DRAINAGE / CIVIL PLAN
VALENTIN RESIDENCE
4350 E. MERCER WAY, MERCER ISLAND, WA 98040

DRAWING NO:
C2.0
APN 004610-0150
1902-013

DRAINAGE DETAILS / STORM PROFILE
 VALENTIN RESIDENCE
 4350 E. MERCER WAY, MERCER ISLAND, WA 98040

DRAWING NO:
C3.5
 APN 004610-0150
 1902-013

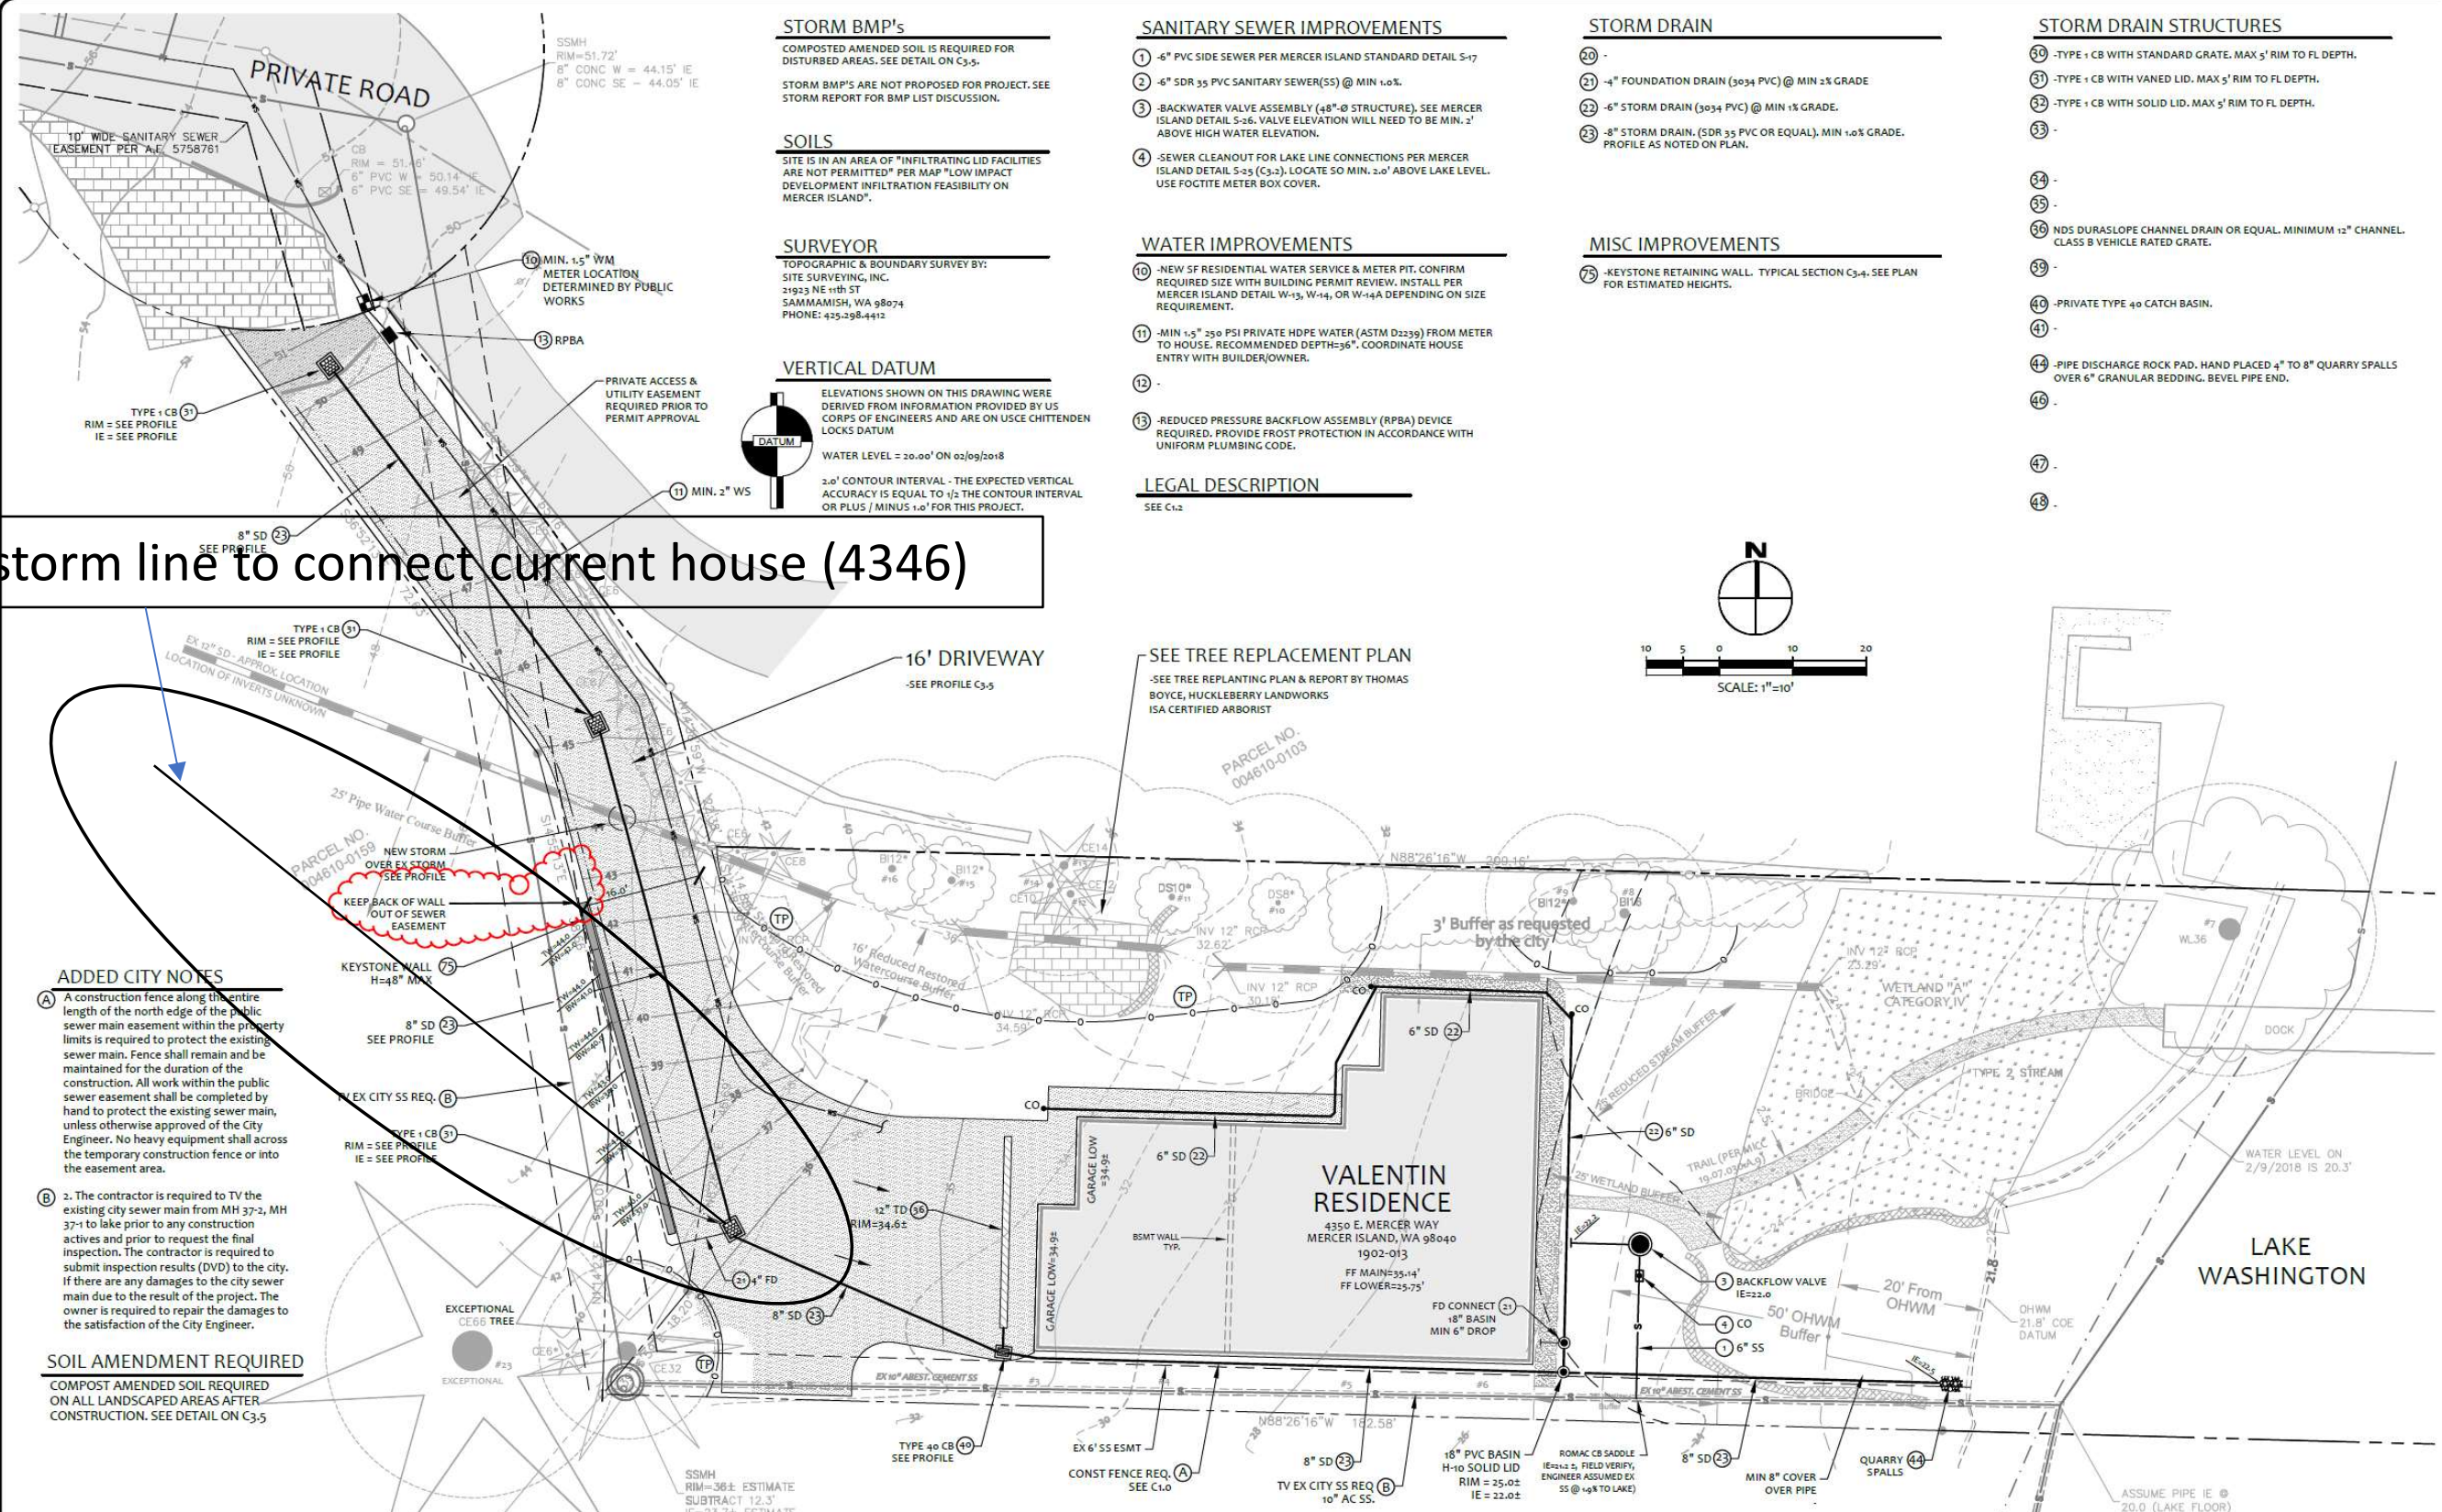
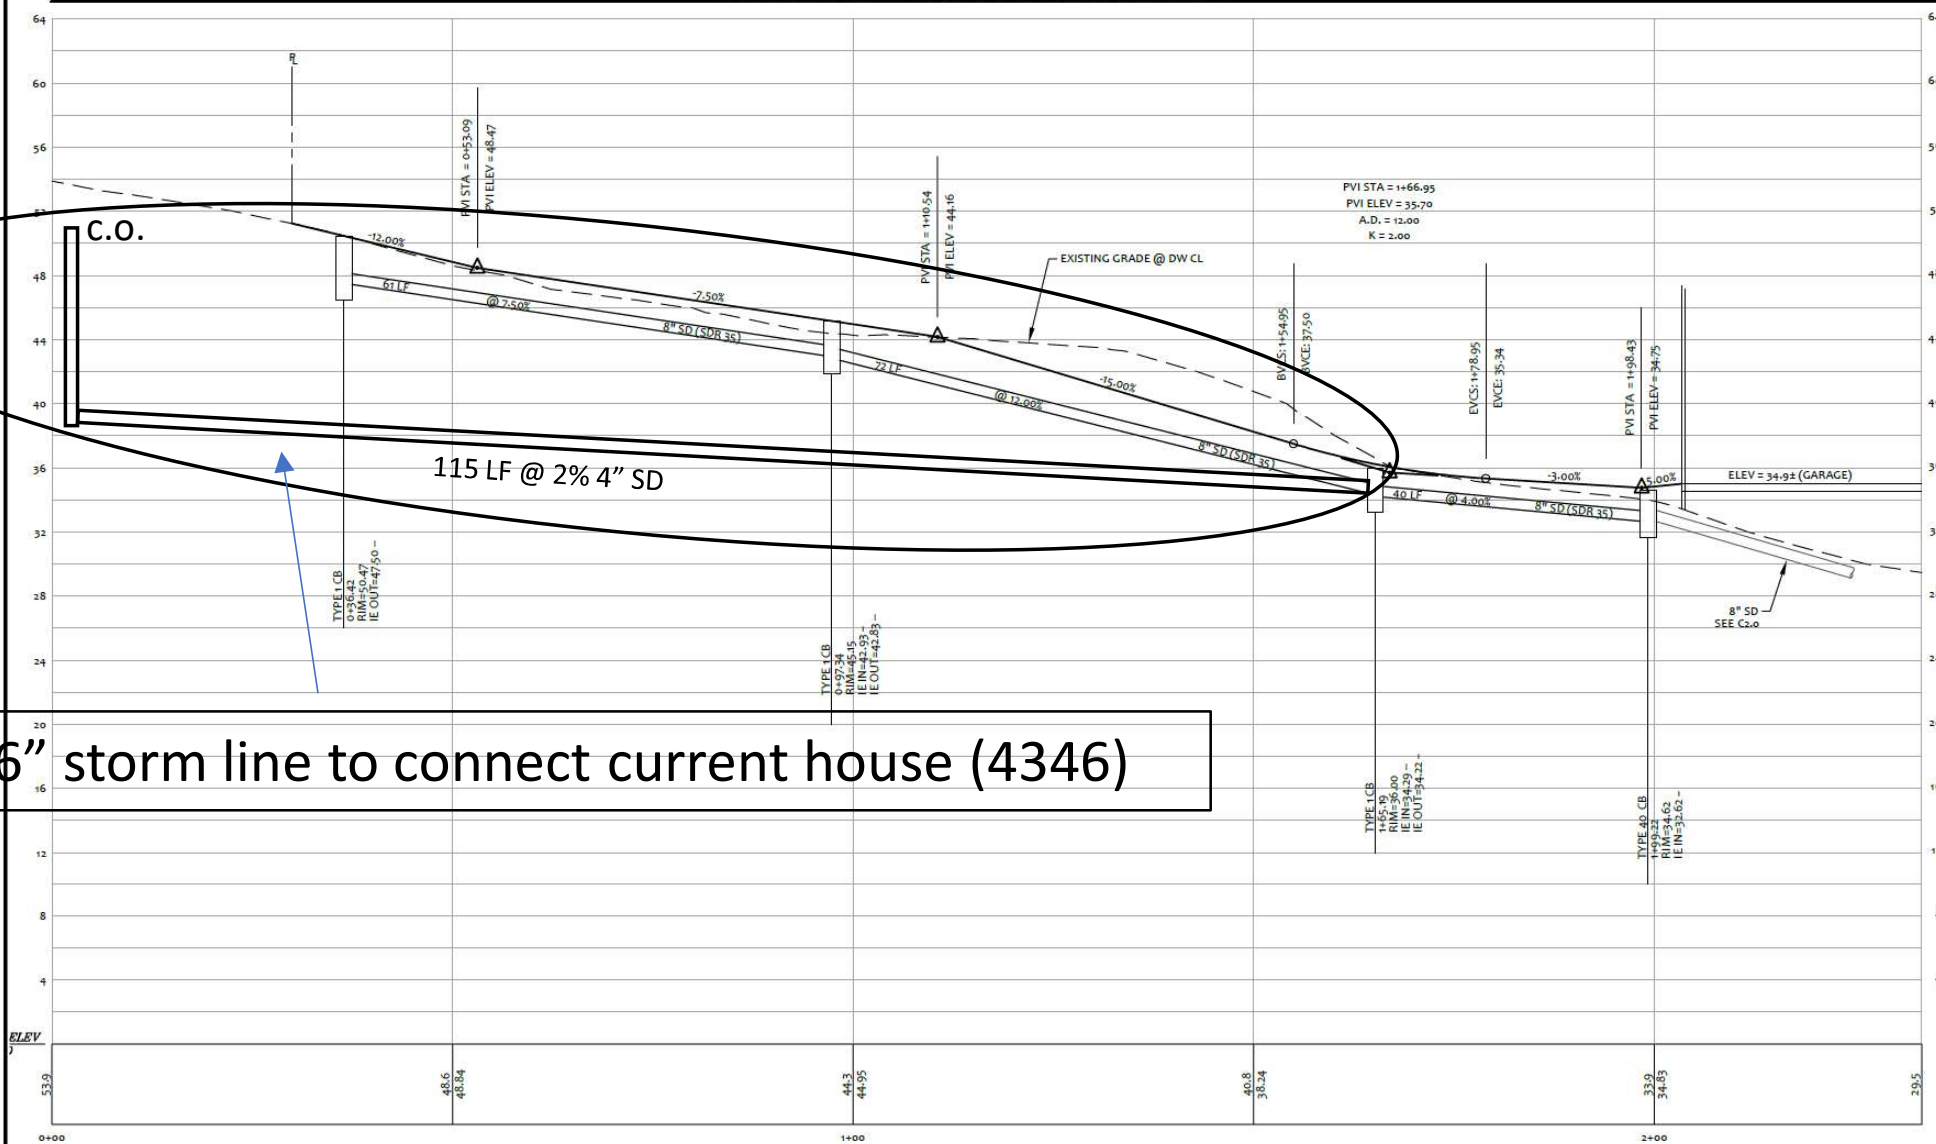
Add 6" storm line to connect current house (4346)

1. A construction fence along the entire length of the north edge of the public sewer main easement within the property limits is required to protect the existing sewer main. Fence shall remain and be maintained for the duration of the construction. All work within the public sewer easement shall be completed by hand to protect the existing sewer main, unless otherwise approved of the City Engineer. No heavy equipment shall cross the temporary construction fence or into the easement area.

2. The contractor is required to TV the existing city sewer main from MH 37-2, MH 37-1 to lake prior to any construction activities and prior to request the final inspection. The contractor is required to submit inspection results (DVD) to the city. If there are any damages to the city sewer main due to the result of the project. The owner is required to repair the damages to the satisfaction of the City Engineer.

PRIVATE DRIVEWAY / STORM PROFILE

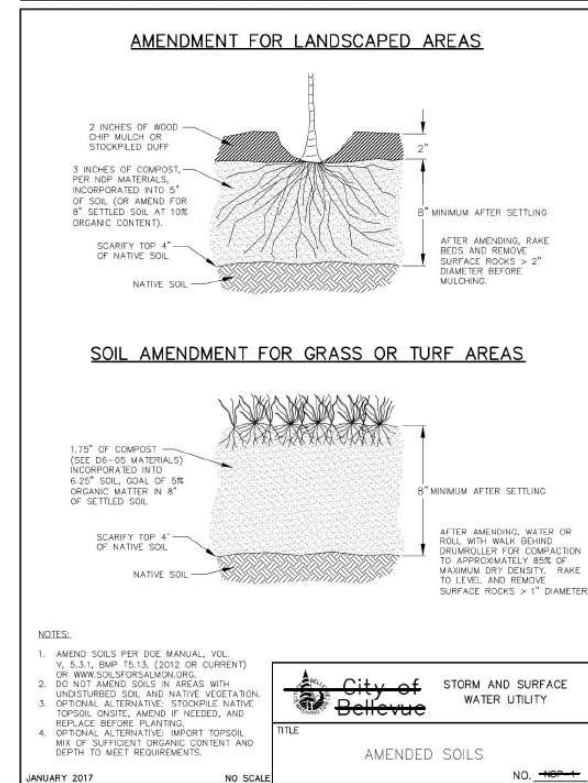
Add 6" storm line to connect current house (4346)
